**Technical Memorandum – Evaluation of Sulfate
Concentrations in Five Monitoring Wells**

Project No.: 00-20655.41

Subject: **Veolia Emerald Park – Response to Comment by Joe Lourigan, WDNR Regarding Increased Sulfate Concentrations in Site Monitoring Wells**

TOTAL SULFATE AT SELECTED WELLS

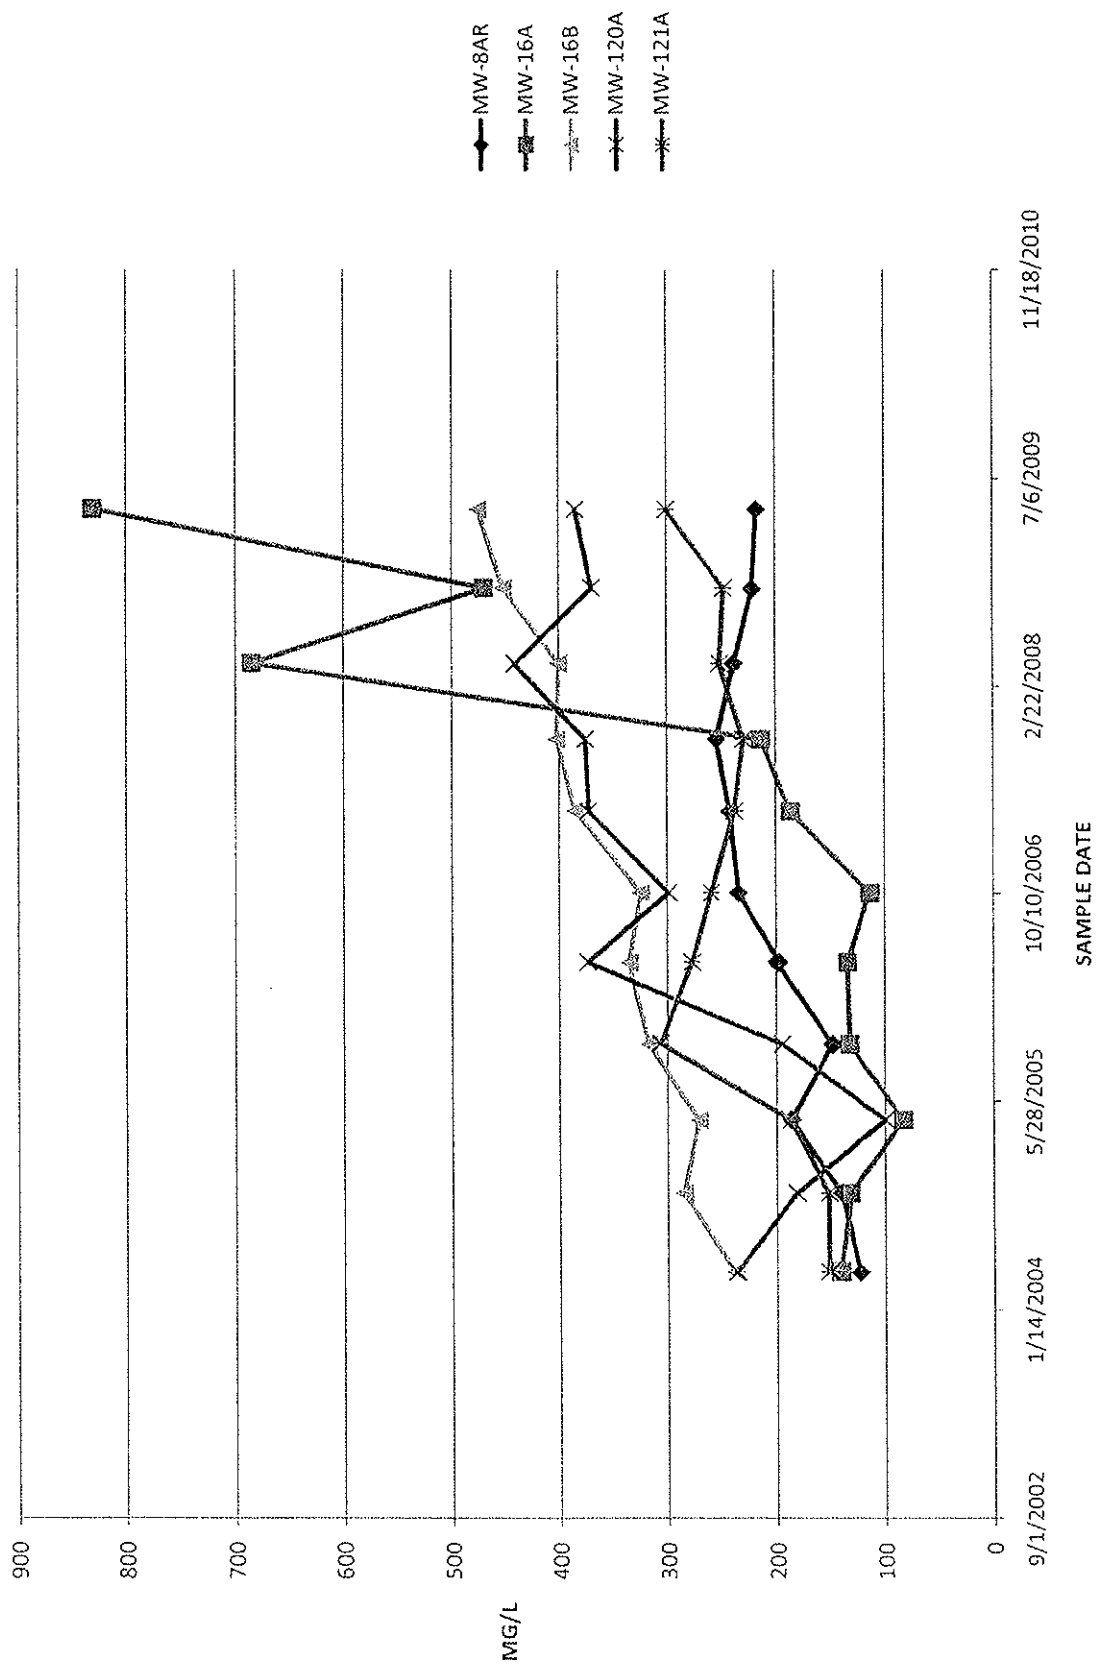
- Review of the graph depicting sulfate concentration in the 5 monitoring wells indicate the following:
 - Well MW-8AR – Sulfate concentrations at this well showed an increasing trend during 2005 and have generally remained stable since that time. This shallow water table well is located along the western edge of the original waste cell installed at the facility. It is located along a portion of the site where inward hydraulic gradients may result in groundwater flow toward the landfill rather than to the west.

- Well MW-16A – Sulfate concentrations at this well show an increase in concentration beginning in late 2007. This shallow water table well is located at the southwest corner of the original waste cell of the facility. A large stock pile of excavated clay from the construction of the Phase 6 waste cell nearly surrounds this location. Excavation of Phase 6 west began in the spring of 2007. It is quite possible that exposure of sulfate or sulfide containing minerals in the stockpiled soil could yield runoff during precipitation events that contains elevated sulfate that in turn could infiltrate into the soil in the vicinity of this well and cause the spike in concentrations.

- Well MW-16B – Sulfate concentrations at this piezometer have been slowly increasing since 2004, but are significantly less than those reported at MW-16A. Well MW-16B was installed as a nested pair with well MW-16A and is completed at a depth of approximately 40 feet below ground surface in a very tight (10^{-8} cm/second hydraulic conductivity) silty clay glacial till. The low groundwater flow rates in the clay at this depth preclude landfill leachate as a source and probably indicate that it may take a number of years to achieve geochemical stability for wells completed in the deeper clay.

- Well MW-120A – Sulfate concentrations in samples from this shallow water table well show an increase in 2005 but then generally have remained stable in the 300 mg/L to 400 mg/L range. Well MW-120A is up gradient of the Emerald Park Landfill facility. This suggests there are significant naturally occurring levels of sulfate in the local groundwater and that these concentrations can vary considerably seasonally and annually.

- Well MW-121A – This well is located side gradient of the facility and is completed as a shallow water table well. The concentrations of sulfate at this well have behaved in a manner very similar to those reported in upgradient well MW-120A.
